The Commission has issued the enclosed Amendment No. 38 to Facility License No. DPR-38; Amendment No. 38 to Facility License No. DPR-47; and Amendment No. 35 to Facility License No. DPR-55 for the Oconee Nuclear Station. These amendments consist of changes to the Station's common Technical Specifications and are in response to your request dated October 1, 1975.

These amendments revise the common Oconee Station Technical Specifications to incorporate changes to the Oconee Unit 1 pressurization, heatup, and cooldown limitations.

SAFETY EVALUATION BY THE OFFICE OF NUCLEAR REACTOR REGULATION

OCONEE NUCLEAR STATION, UNITS NOS. 1, 2 AND 3

Figure 3.1.2-1A

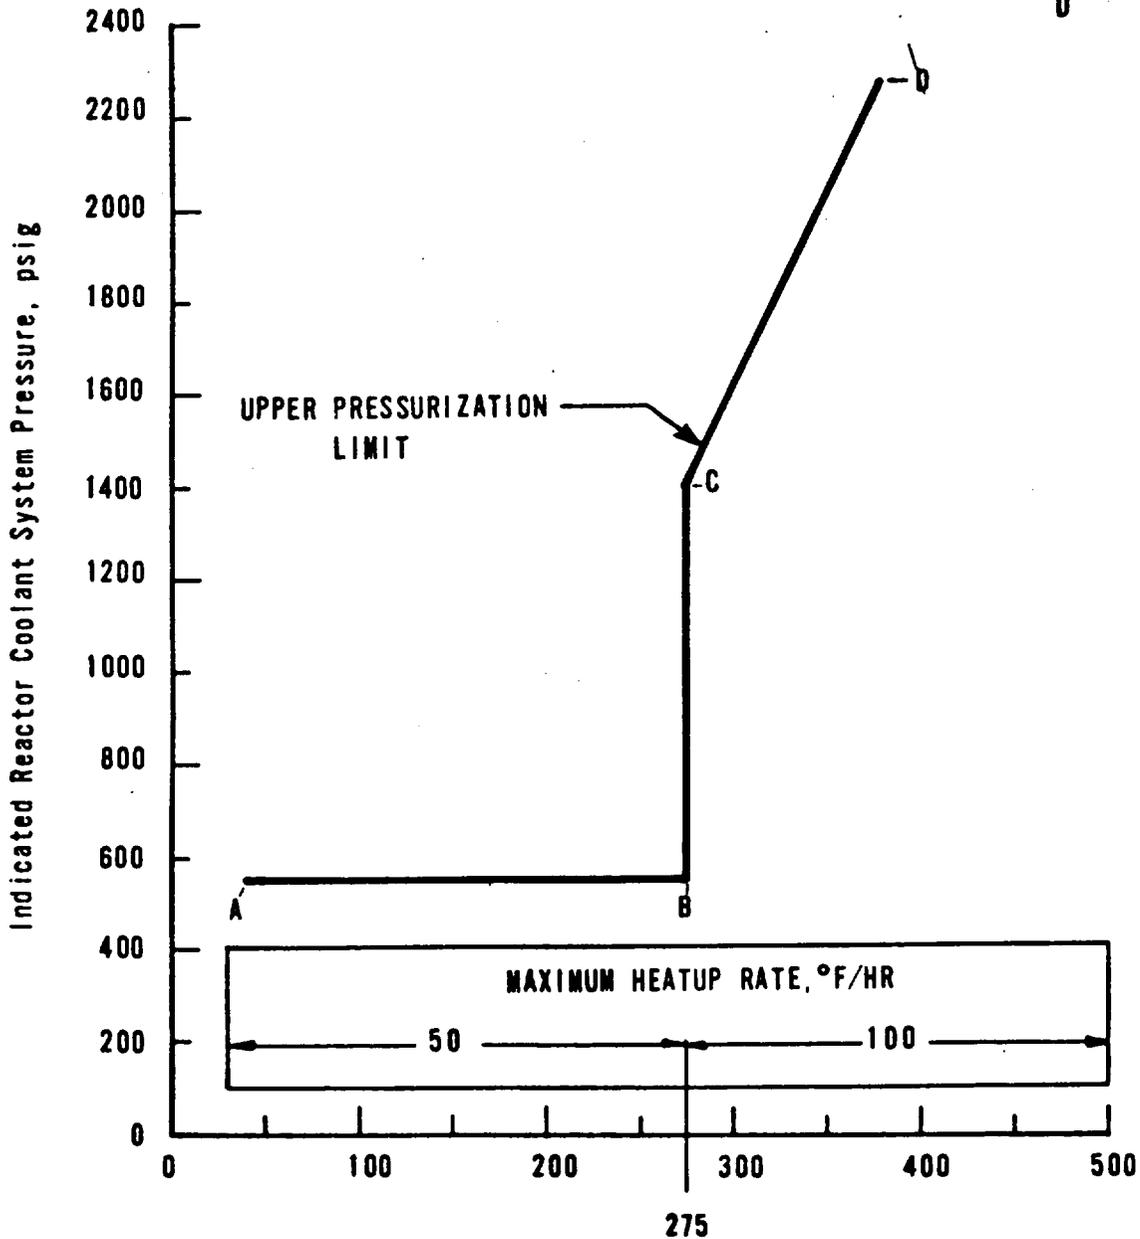
The Oconee Unit 1 pressure-temperature operating limit curves, Figures 3.1.2-1A, 3.1.2-2A and 3.1.2-3 are based on calculations for operation through 5 effective full power years (EFPY). These curves were prepared based on data from a Babcock & Wilcox Report, "Analysis of Capsule OC1-F From Duke Power Company Oconee Unit 1 Reactor Vessel Materials Surveillance Program," BAW-1421 Revision 1, dated September 1975.

We have reviewed BAW-1421, Revision 1 and the proposed pressure-temperature operating limit curves. The data does not adequately support the use of these curves for 5 EFPY. We have, therefore, performed independent calculations based on the methods of Regulatory Guide 1.99. Based on our independent calculations and our review of BAW-1421, we have concluded however, that the use of these curves is acceptable through 4 EFPY.

Following discussion with the licensee, the amendment has been prepared reflecting this limitation.
